**AltaLink Management Ltd.  
2022-2023 General Tariff Application and  
2020 Direct Assigned Capital Deferral Account  
Reconciliation Application**

**Corrigenda to Decision 26509-D01-2022**

**Alberta Utilities Commission**

Decision 26509-D01-2022 (Corrigenda)

**Figure 1. AltaLink’s area map of transmission line 799L**

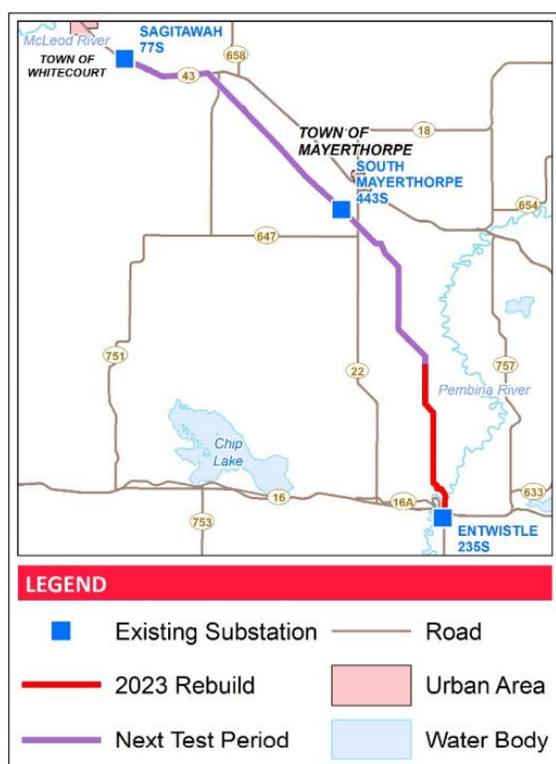
172. AltaLink’s evidence is that transmission line 799L has the second highest probability of failure for a wood pole line in the AltaLink system. It has been identified in the top 10 per cent of all lines in AltaLink’s system for probability of failure.<sup>143</sup> In its compliance filing, the Commission requires AltaLink to explain why any other potential alternatives are not feasible, including the installation of two circuit breakers at the South Mayerthorpe 443S Substation.

173. Transmission line 799L is the only supply source to the South Mayerthorpe 443S Substation. That substation demarcates the north segment of transmission line 799L from the south segment. AltaLink proposed to rebuild the first 20 kilometres (km) of its south segment at a forecast capital expenditure of \$6.0 million in 2023, with the remainder of the 77 km of transmission line 799L to be rebuilt by segment in subsequent test periods.<sup>144</sup>

176. There are significant potential cost differences between rebuilding transmission line 799L and potential alternative solutions such as installing two circuit breakers at the South Mayerthorpe 443S Substation. Accordingly, in its compliance filing, the Commission directs AltaLink to explain in detail, why a solution similar to the proposed project for the Niton 228S Substation or any other potential alternative solutions, are not feasible for transmission line 799L. In its explanation, AltaLink should include the forecast costs of all potential alternative solutions examined.

**Figure 2. SCADA notifications trend in 2016 to 2020**

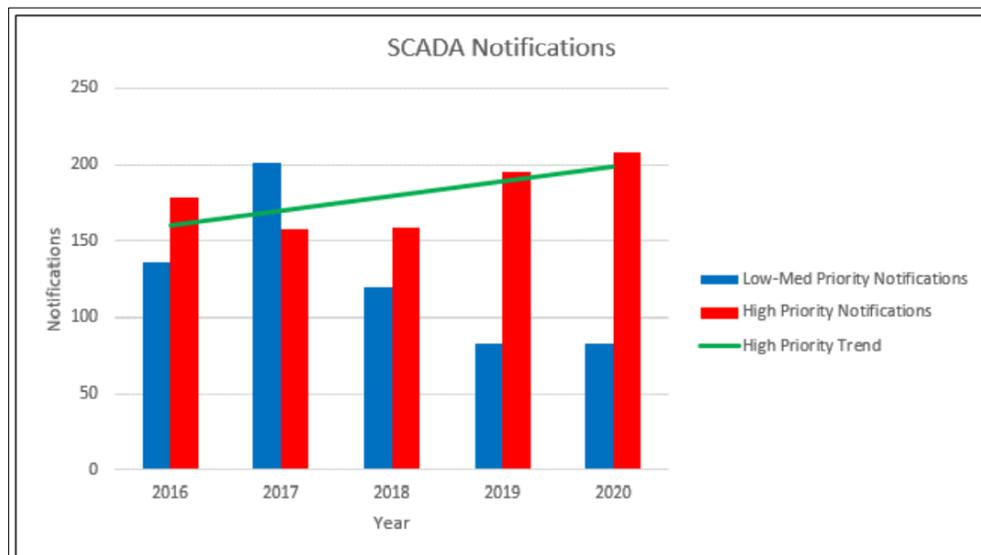
212. The Commission does not find that Figure 2 supports the conclusion there is an upward trend in SCADA notifications. Prior to 2019, high-priority notifications were decreasing, but then increased in 2019 and 2020. The Commission does not consider two years of increased high-priority notifications to be sufficient to conclude a sustained upward trend exists.

213. Further, the Commission agrees with N. Tauh, on behalf to the CCA, that the notifications, as presented by AltaLink, are vague and lack context.<sup>199</sup> The Commission finds conclusions cannot be drawn as to the underlying causes of changes in the number of notifications (even when they are broken down to a slightly more granular level, as provided by AltaLink in an information response)<sup>200</sup> because the descriptors AltaLink used provide few details as to what the issues actually were. Regardless, the Commission notes that numerous items for which AltaLink records notifications may not be indicative of the need to replace a device. Items such as requests to modify settings and configuration files, planned maintenance activities being completed and tests of fault reporting capabilities<sup>201</sup> do not necessarily indicate the need to replace SCADA devices in the future.

**Figure 3. SCADA equipment failure rate curves**

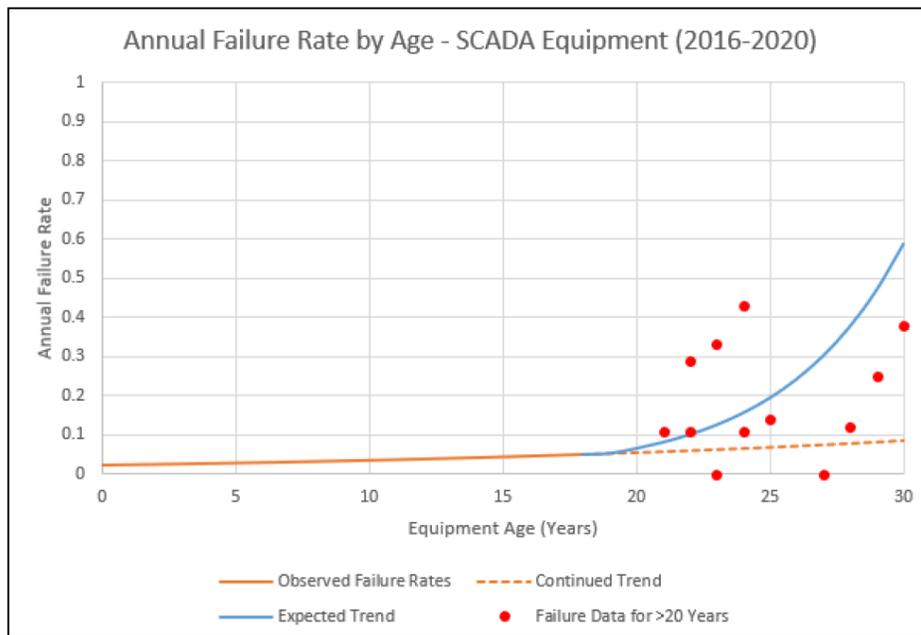
216. To generate the “expected trend” curve in Figure 3, AltaLink relied on observed failures of three of its oldest SCADA systems over the last four years.<sup>203</sup> These failures are depicted by the red dots in Figure 3 above. Approximately 97 per cent of AltaLink’s SCADA equipment is 18 years old or less.<sup>204</sup> Accordingly, AltaLink has minimal data on SCADA systems older than 20 years, as shown in the figure below.

Figure 4. Age profile of SCADA RTUs

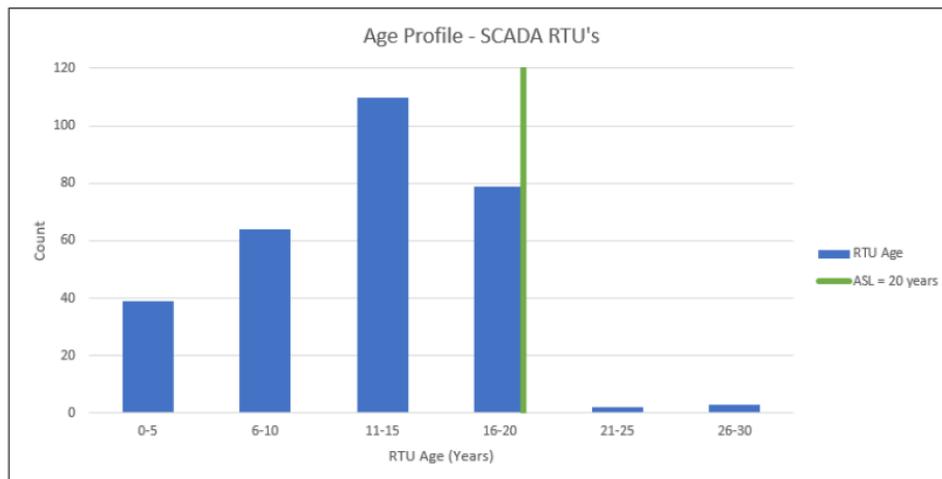
218. The Commission notes, however, that the higher number of observed failures on these three SCADA systems suggest that replacement of these systems in the near term may be reasonable. However, AltaLink is proposing to upgrade SCADA systems at 27 sites<sup>206</sup> in the test period, far more than would be necessary to address these three poor-performing systems. As AltaLink has admitted, the “observed trend” curve, represented by the solid orange line in Figure 3, for which AltaLink had sufficiently more data points to generate, does not support the requirement to replace SCADA devices at a specific age.<sup>207</sup>

**Figure 5. AltaLink's protection and control notifications**

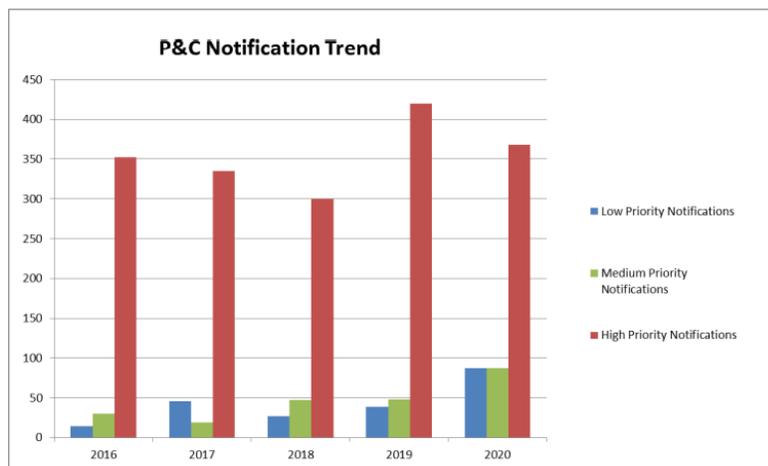
291. In support of the need for protection replacements, AltaLink cited an increasing and sustained trend in high-priority notifications for protection and control devices.<sup>294 295</sup> The chart below shows the five-year trend for protection and control notifications:
